Viewfinder Updates 8/5/24

- Single Shot in DDR
- Perpendicularity
- SID Indicator

Legacy Enhancement

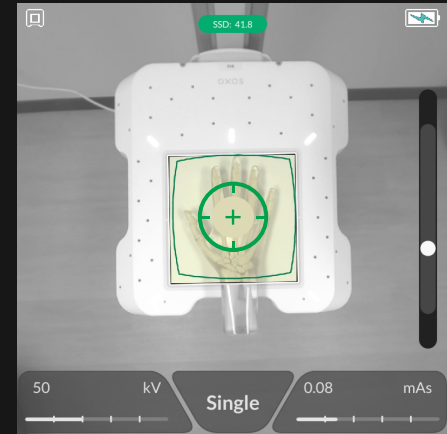
Color Change, Larger Size, Bolder Line

- Legacy Enhancement Approved (Center crosshair/bubble level)
 - Explore details for refinement
 - User Study & Review Refinement

SID Indicator

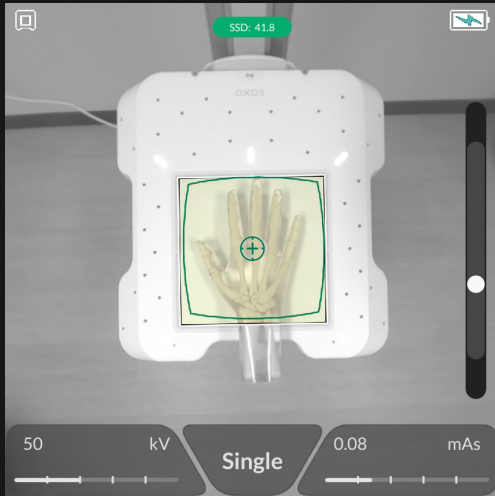
- It is difficult to understand that the SID Gauge is relaying SID
- It is difficult to look between the tablet (to view the SID value) and the Emitter (to position the device) and then back again

- Include SID value on viewfinder
- Include SID Label on Viewfinder
